# **FINAL ENVIRONMENTAL IMPACT REPORT FOR THE BAYHILL SPECIFIC PLAN INCLUDING PHASE I DEVELOPMENT**

**August 2021**

# Comments Received on the Draft EIR

**Figure 1:** Project Area and SFO 65 dB CNEL contour

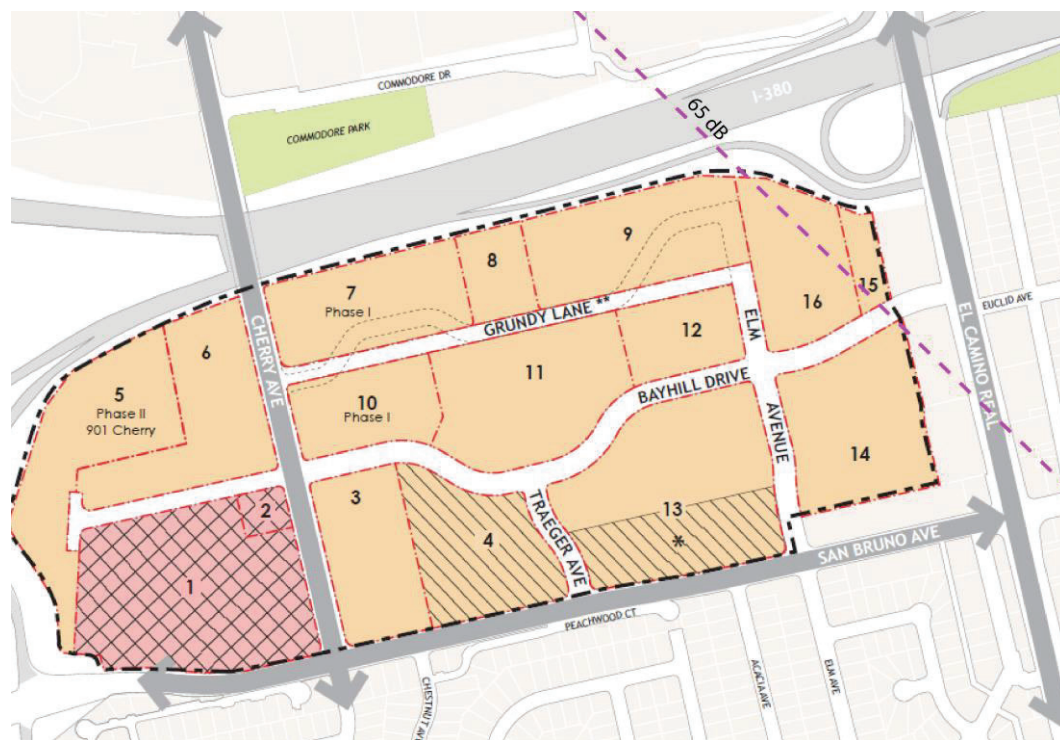
The Airport would like to amend its prior comments to state that the northeastern portions of Parcels 15 and 16 are within the 65 decibel (dB) Community Noise Equivalent Level (CNEL) contour for SFO (see Figure 1). The Airport understands Parcels 15 and 16 are within the Bayhill Regional Office (BRO) zone and would allow for hotels and ancillary uses, including childcare facilities. Because Parcels 15 and 16 are within the 65 dB CNEL contour, any development of these parcels would be subject to the provisions of ALUCP Policy NP-3 and Table IV-1, which, among other things, limit the types of development allowable and require sound insulation and the grant of an aviation easement for certain types of development. The Bayhill Specific Plan and YouTube Phase I development should include and apply these requirements.

The commenter includes a figure that correctly depicts the location of the 65 dB CNEL contour in relation to the Project Site. The 65 dB CNEL contour is also shown in Figure 3.7-1, Year 2020 Airport Noise Contours, in Section 3.7, *Noise*, of the Draft EIR.

Figure 1: Modeled Sewers Within and in Vicinity of Bayhill Specific Plan Area

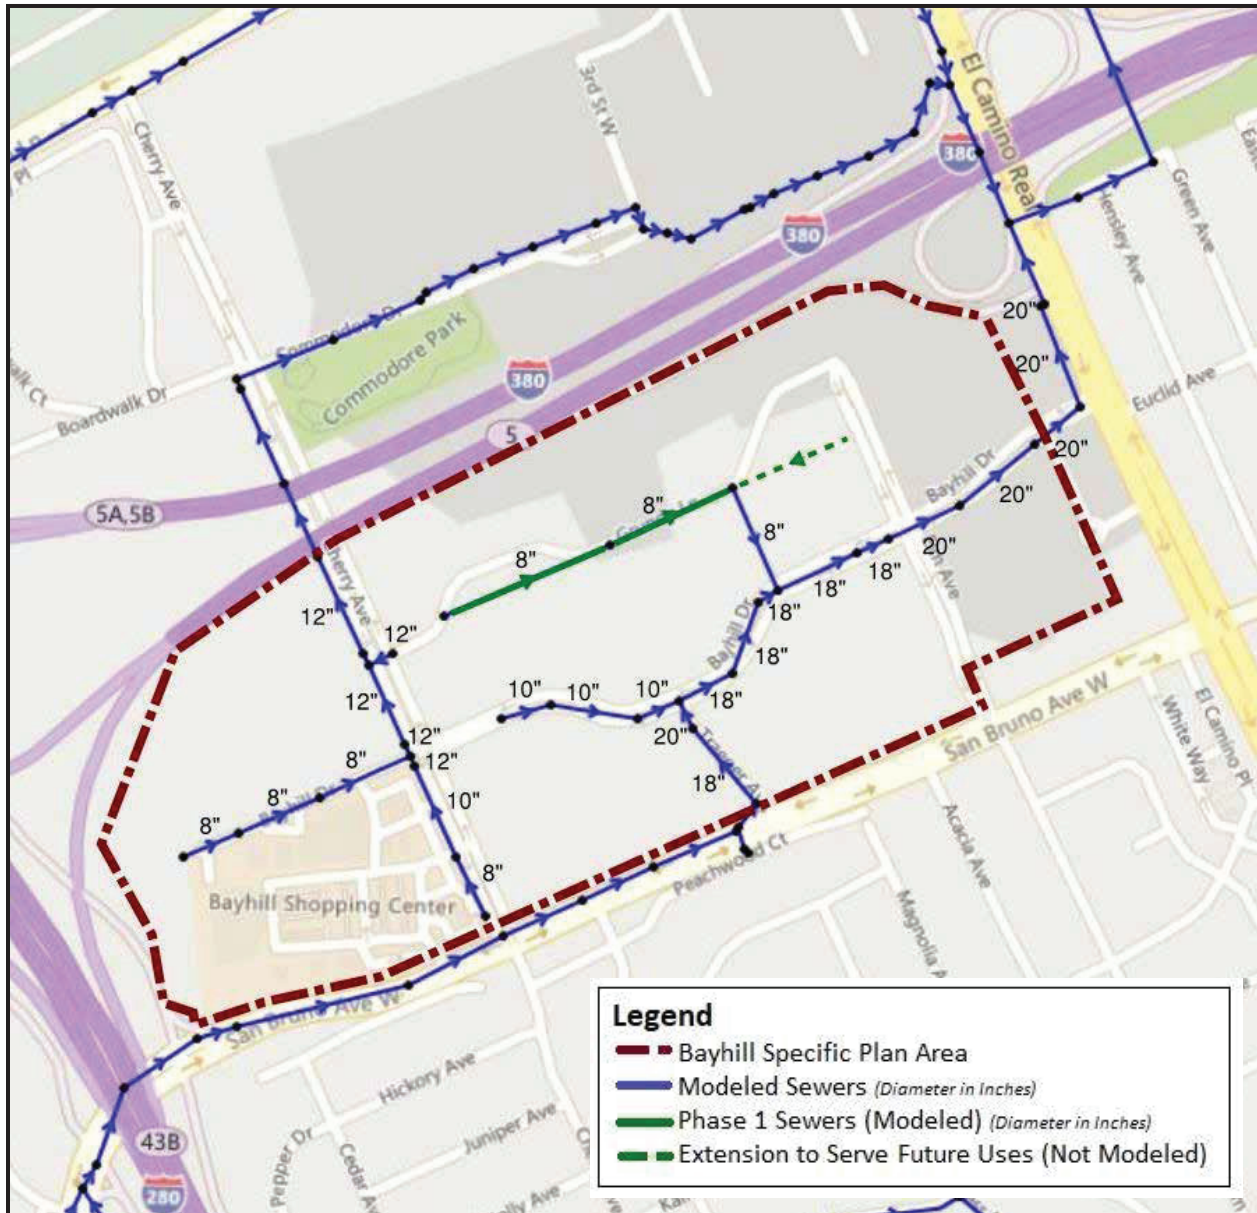
p. 3, Figure 1 (Modeled Sewers Within & in Vicinity of BHSP Area)	Should the 8" lines be shown as 10" since later text suggests that is what was modeled?	6-44
<b>Appendix 3.11-3 Sanitary Sewer Impact Study</b>

Should the 8" lines be shown as 10" since later text suggests that is what was modeled?

The comment asks if the 8-inch lines appearing on Figure 1 of Appendix 3.11-3, *Sanitary Sewer Impact Study*, of the Draft EIR should be shown as 10-inch lines since the text suggests that 10-inch lines were modeled.
